CALL NO. 206  
CONTRACT ID NO. 121354  
ADDENDUM # 2

Subject: Trigg-Marshall Counties, 121GR12D054-BRO  
Letting November 16, 2012

- (1) Revised - Plan Sheets - R1, R2A, R2B, R7, R8, R13, R14, R31, R32, R33, R35, R36, R38, R40, R41, R83, R85, X14, X15, X16, X18, X20, X21, & X26
- (2) Deleted - Plan Sheets - R25, R26, & R86 through R90
- (3) Revised - Front Page of Proposal
- (4) Revised - Completion Date - Page 4 of 177
- (5) Added - Dynamic Pile Testing - Pages 78(a)-78(c) of 177
- (6) Added - Static & Pseudo-Static Pile Testing - Page 96(a) of 177
- (7) Revised - Material Summary - Pages 130-132(a) of 177
- (8) Revised - Bid Items - Pages 173-175 of 177

BRO 0801 (093)  
RECONSTRUCT US 68 / KY 80  
GRADE & DRAIN PLANS

COUNTY OF	ITEM NO.	SHEET NO.
MARSHALL/TRIGG	1-180.75	R31

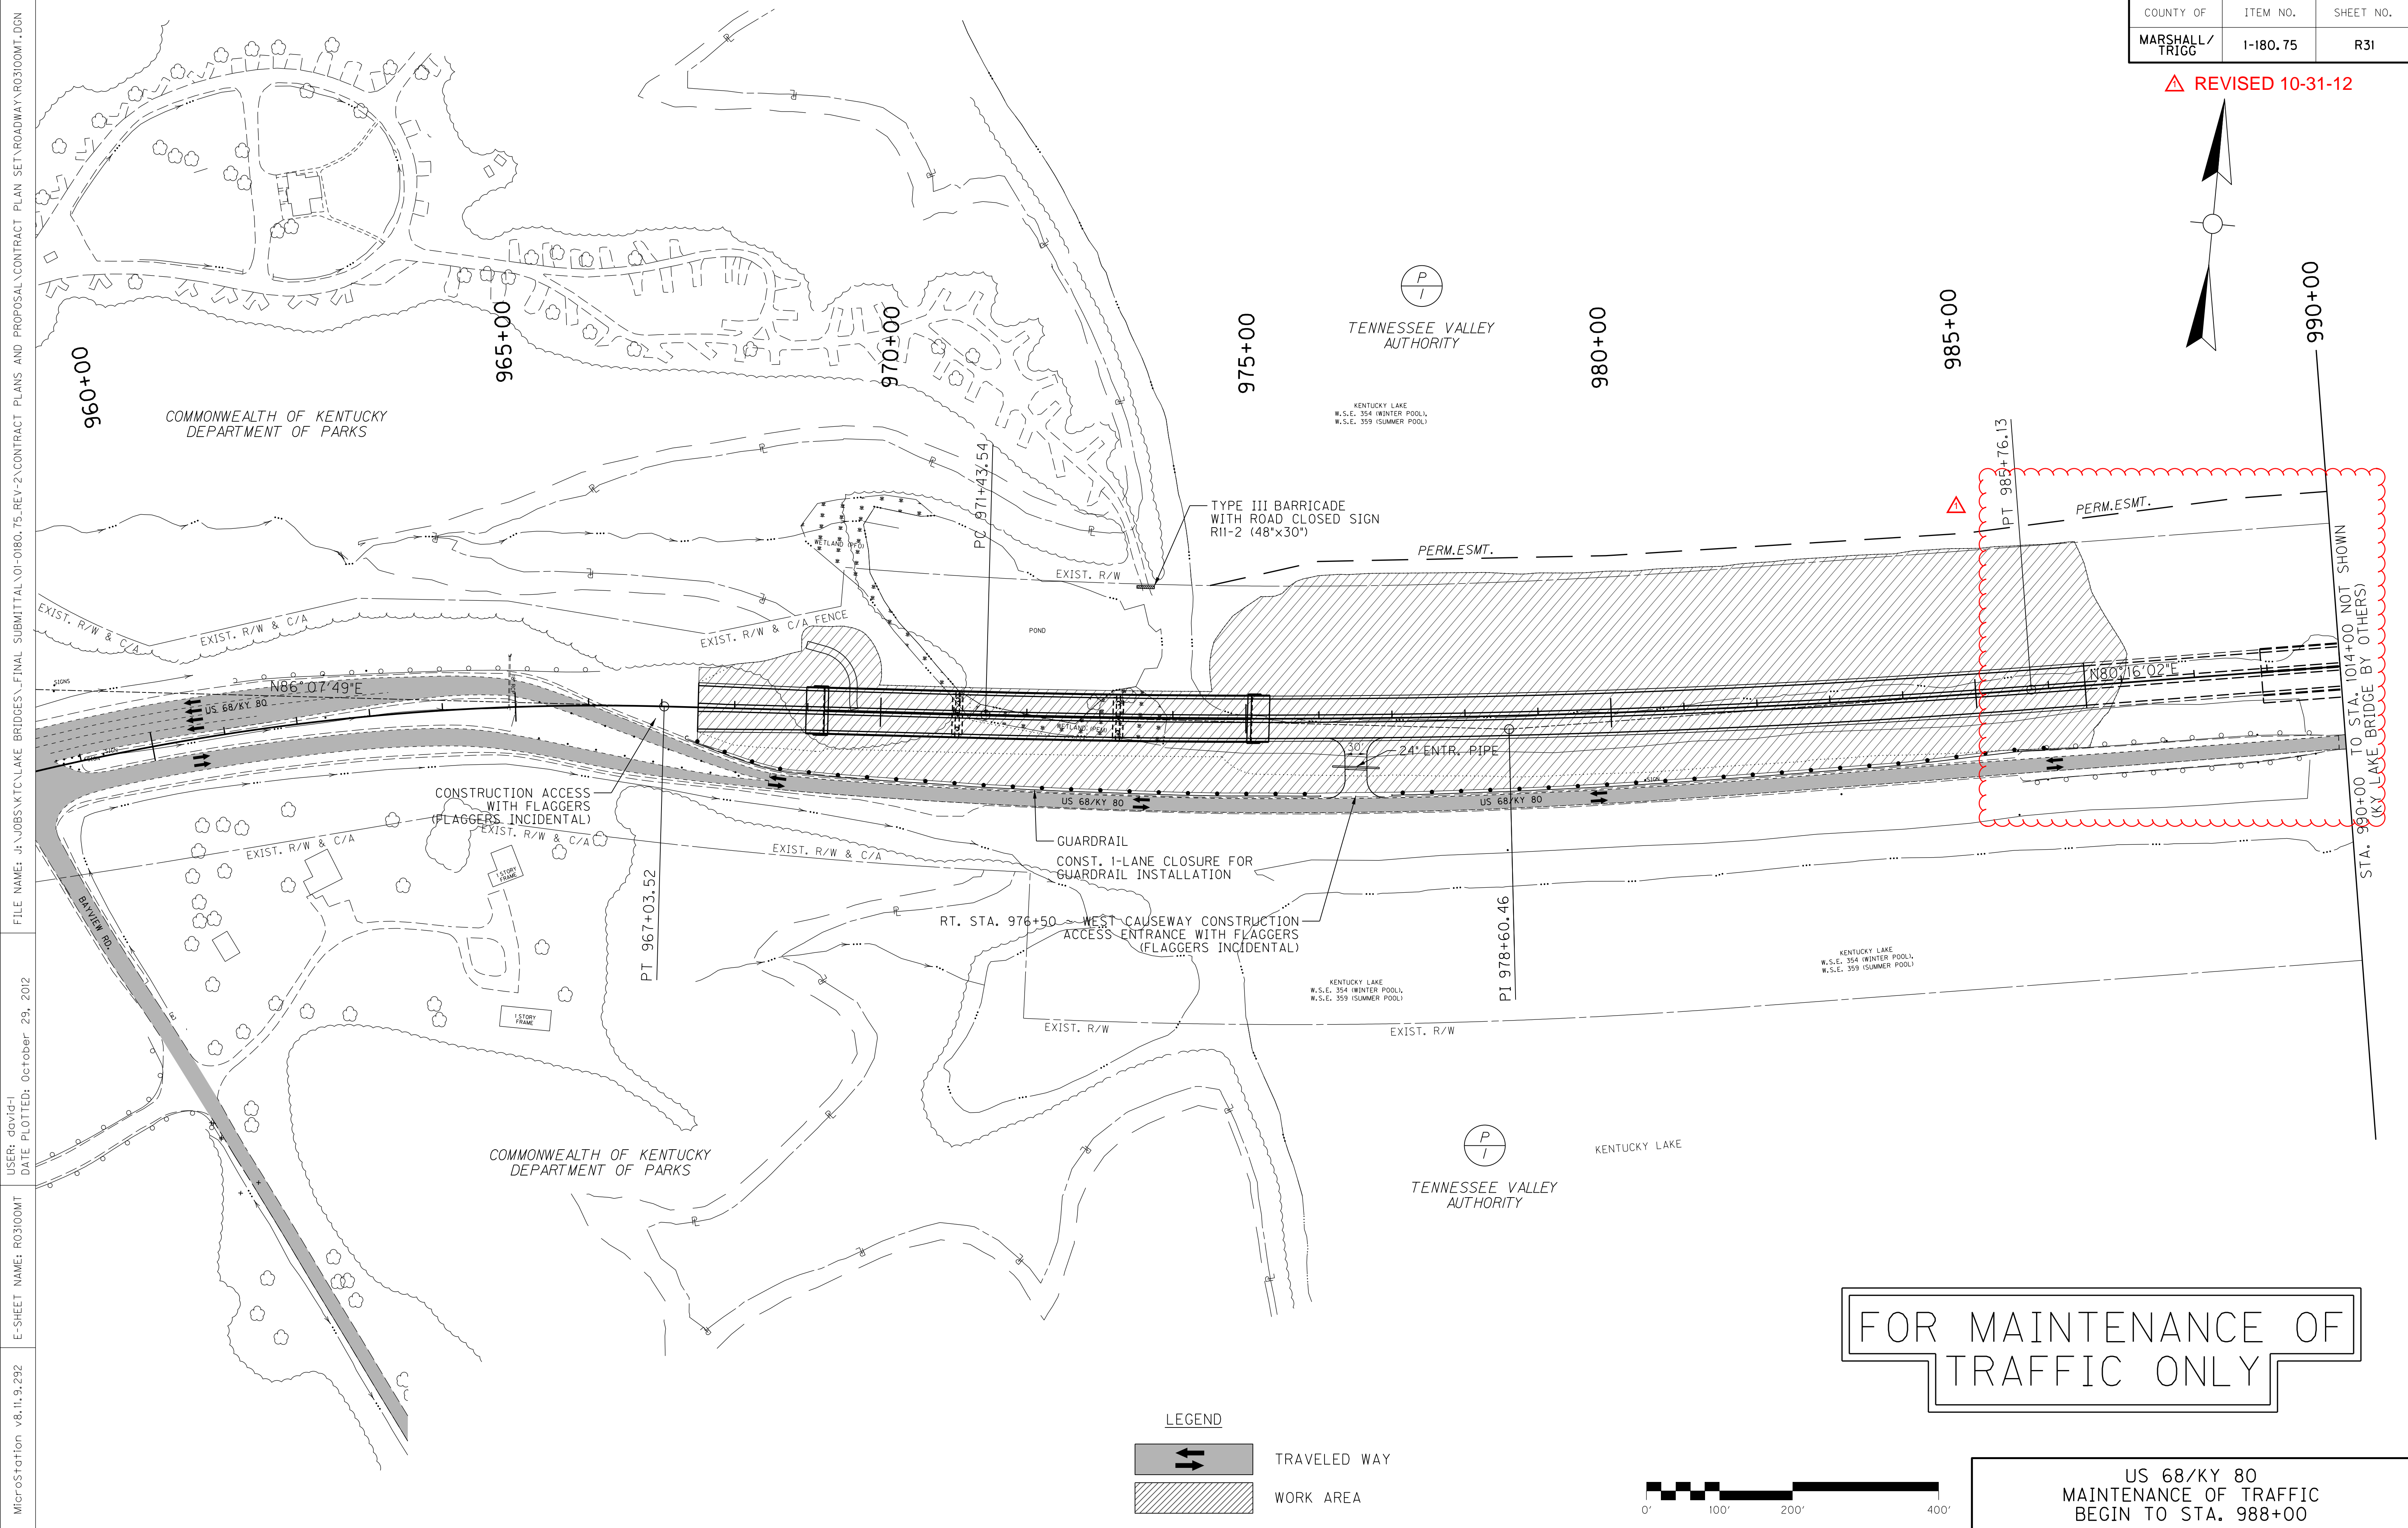
△ REVISED 10-31-12

US 68/KY 80  
 STA. 978+00 TO STA. 993+00  
 EROSION CONTROL PLAN

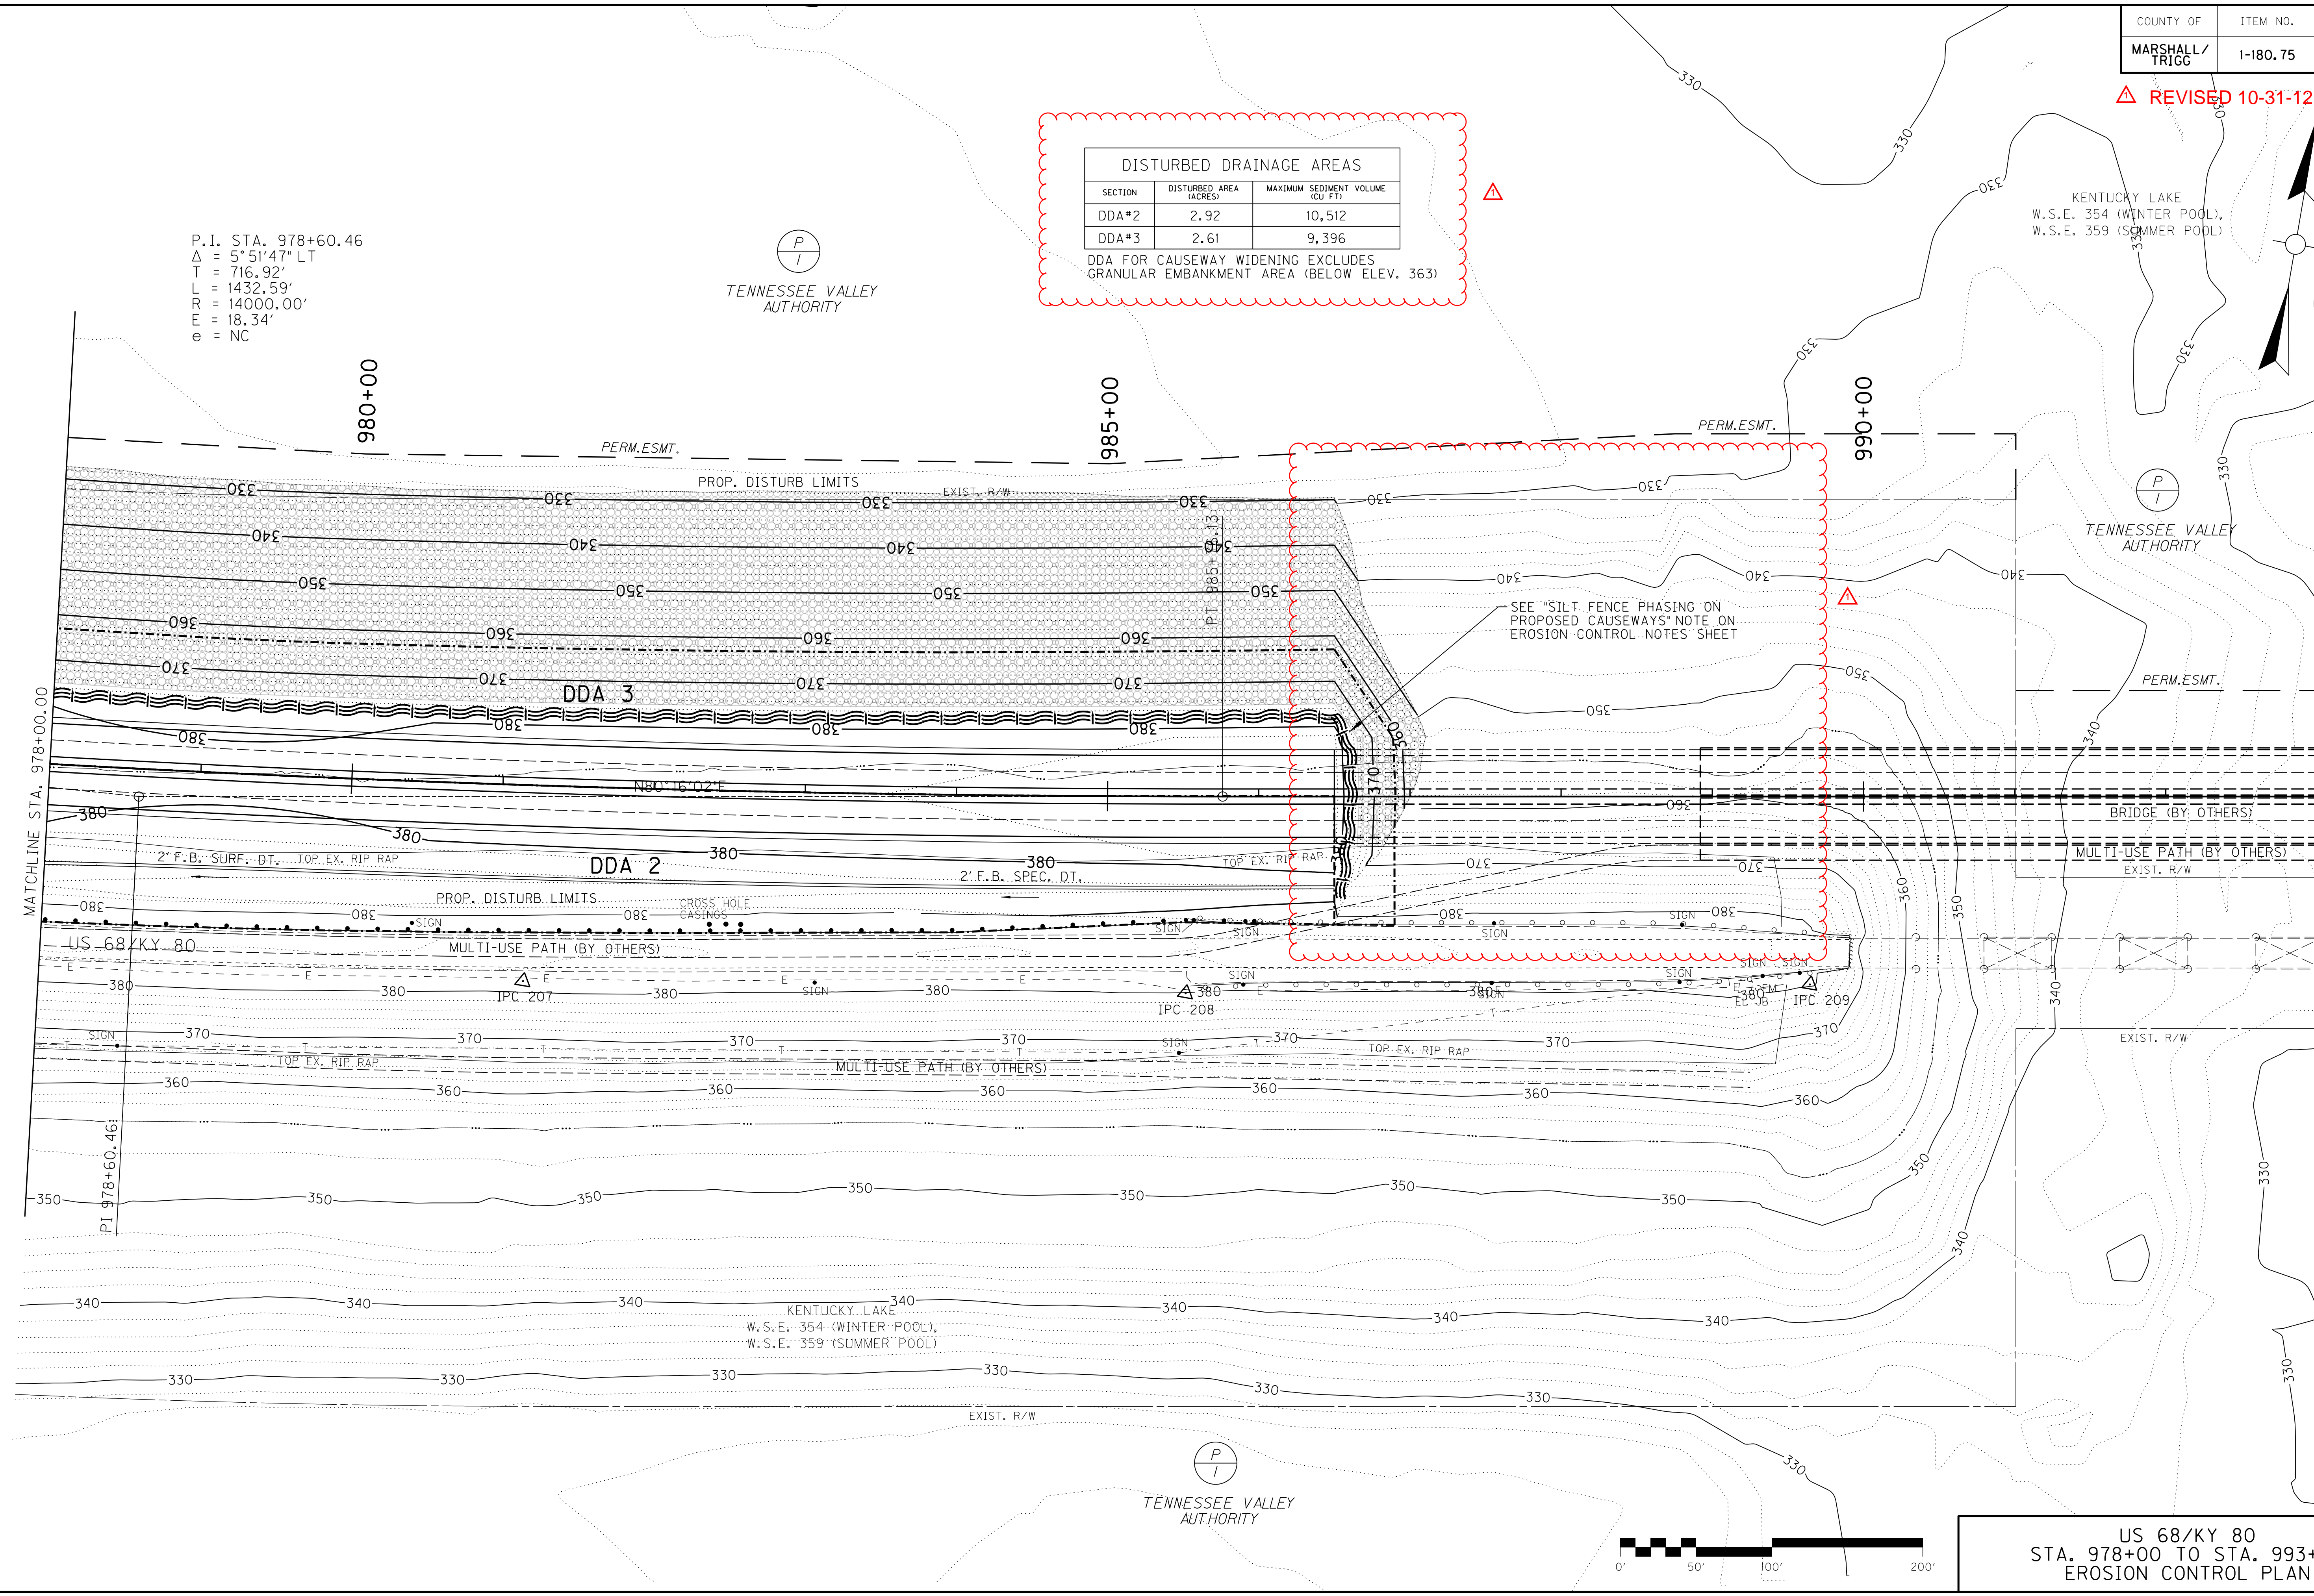
△ REVISED 10-31-12

SECTION	DISTURBED AREA (ACRES)	MAXIMUM SEDIMENT VOLUME (CU FT)
DDA#2	2.92	10,512
DDA#3	2.61	9,396

DDA FOR CAUSEWAY WIDENING EXCLUDES GRANULAR EMBANKMENT AREA (BELOW ELEV. 363)

US 68/KY 80  
STA. 1023+00 TO STA. 1034+50  
EROSION CONTROL PLAN

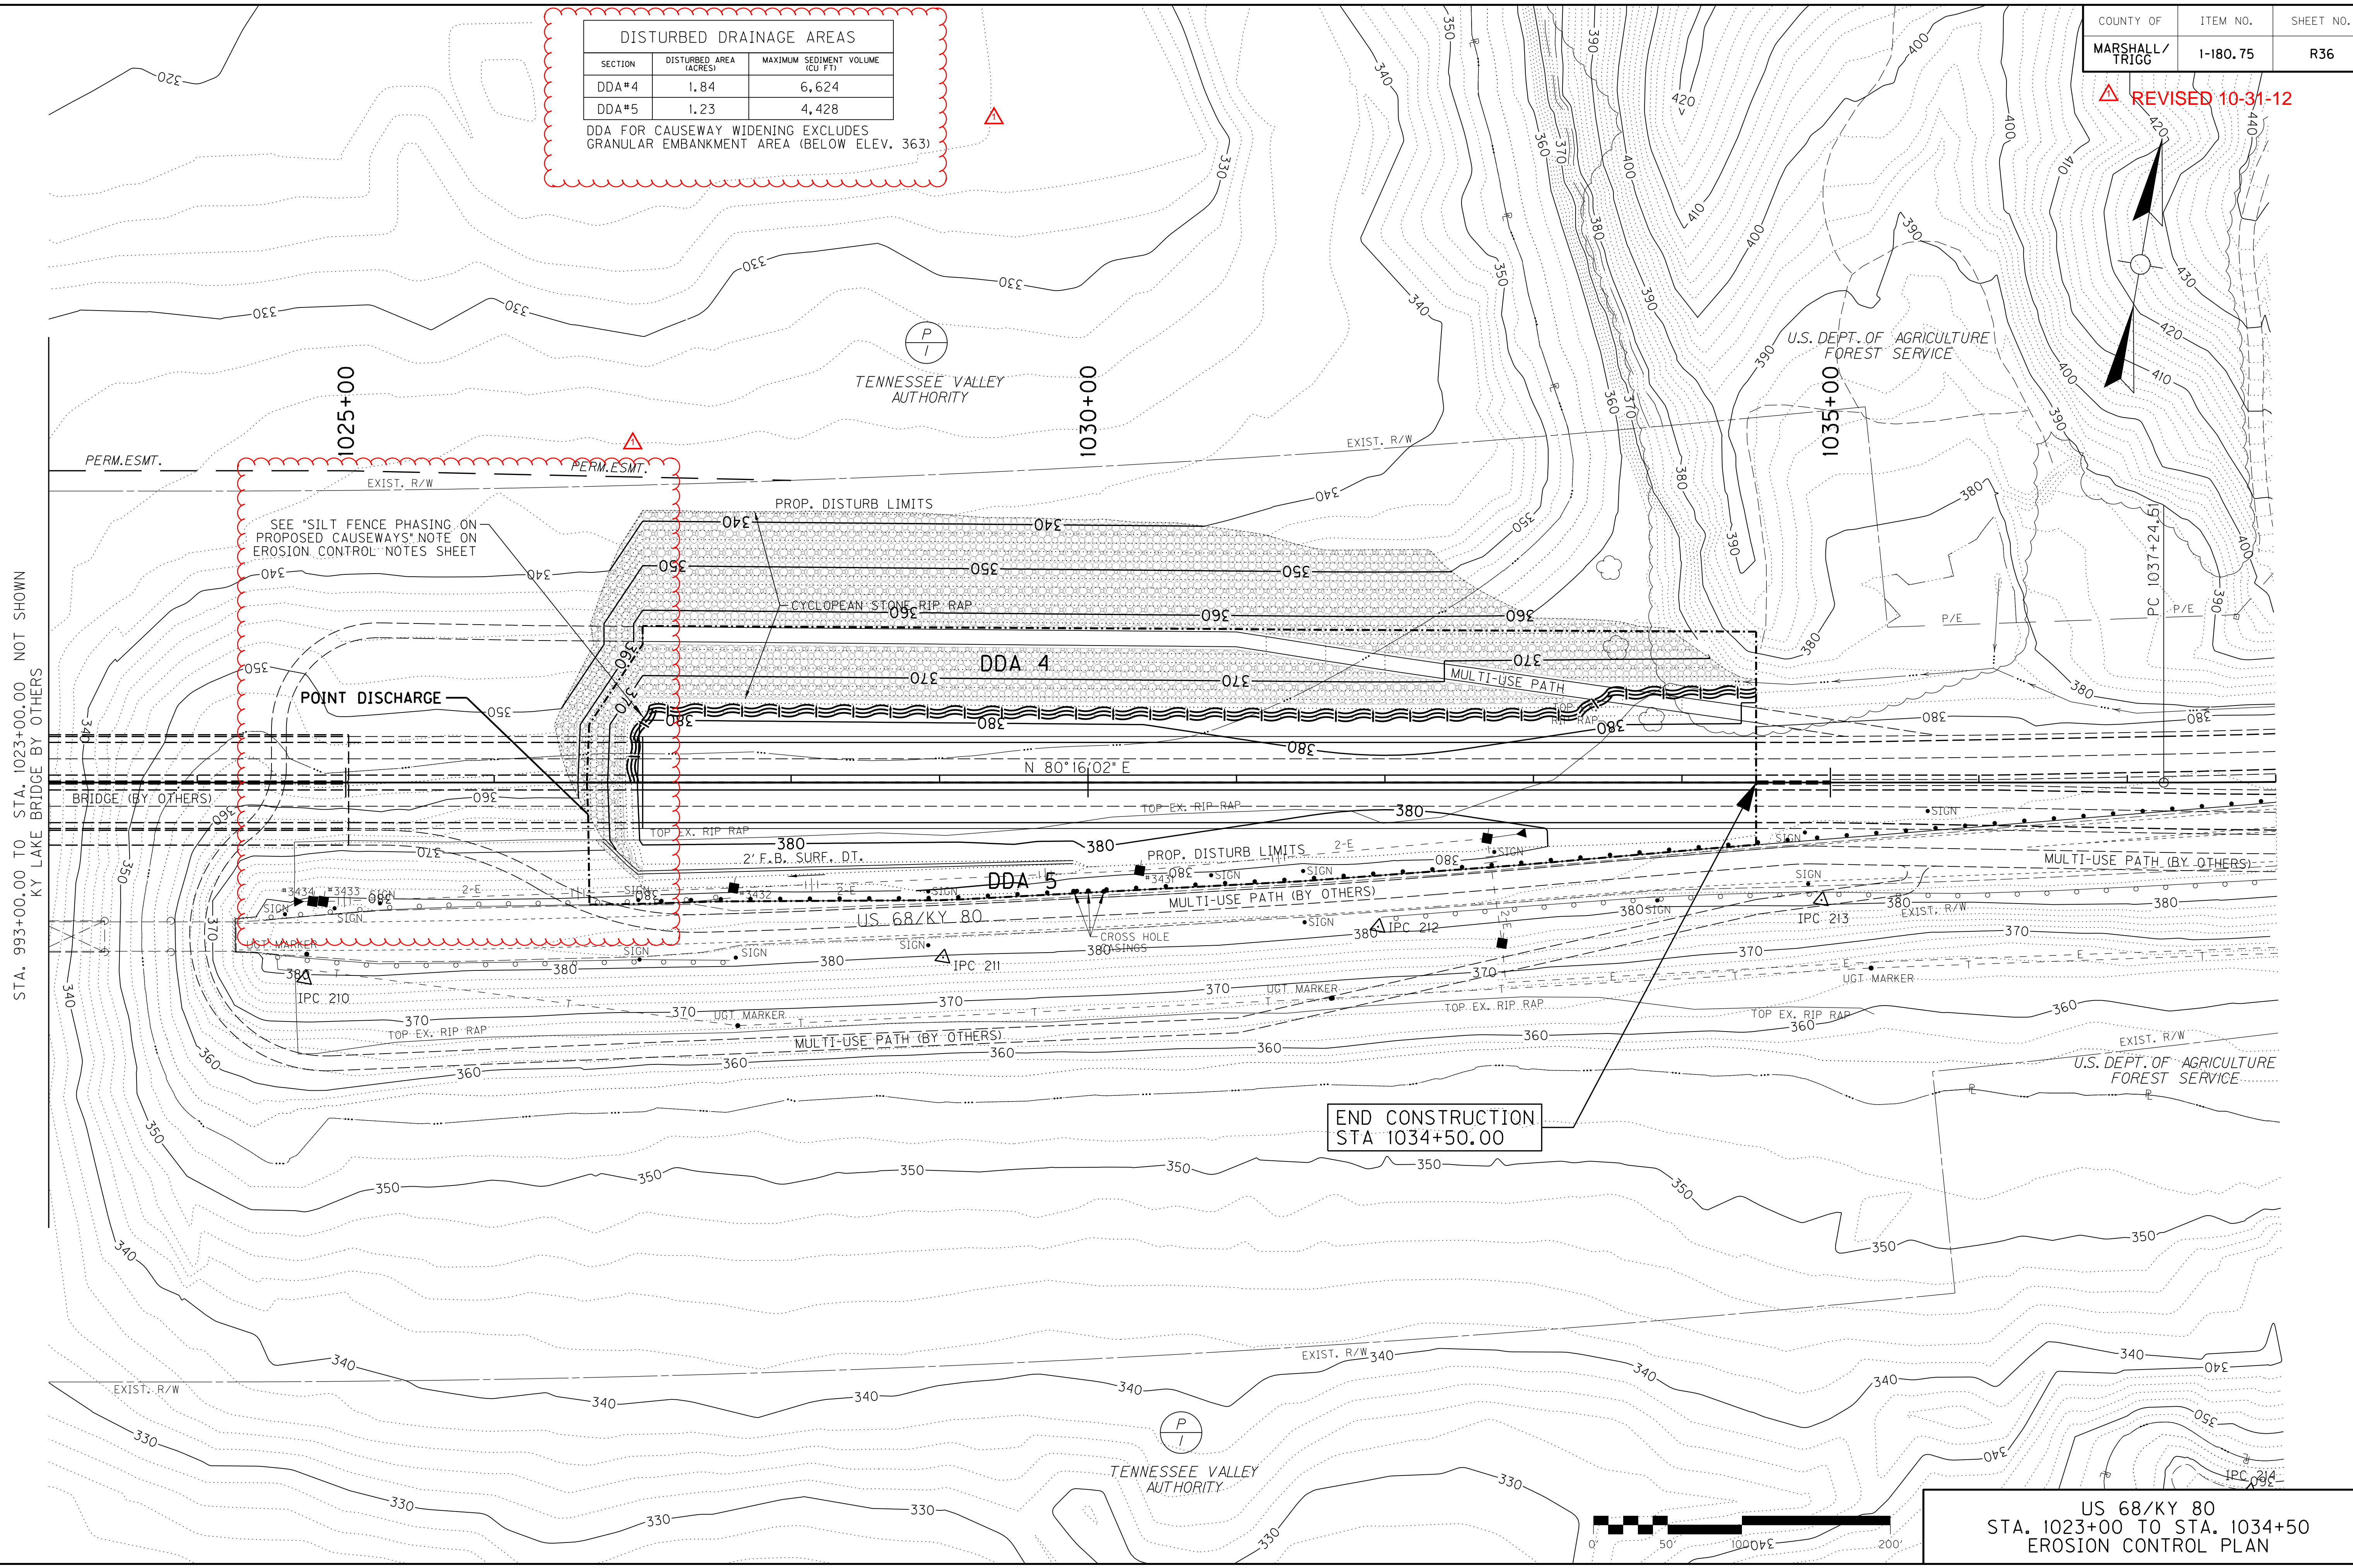
REVISED 10-31-12

SECTION	DISTURBED AREA (ACRES)	MAXIMUM SEDIMENT VOLUME (CU FT)
DDA#4	1.84	6,624
DDA#5	1.23	4,428

DDA FOR CAUSEWAY WIDENING EXCLUDES GRANULAR EMBANKMENT AREA (BELOW ELEV. 363)
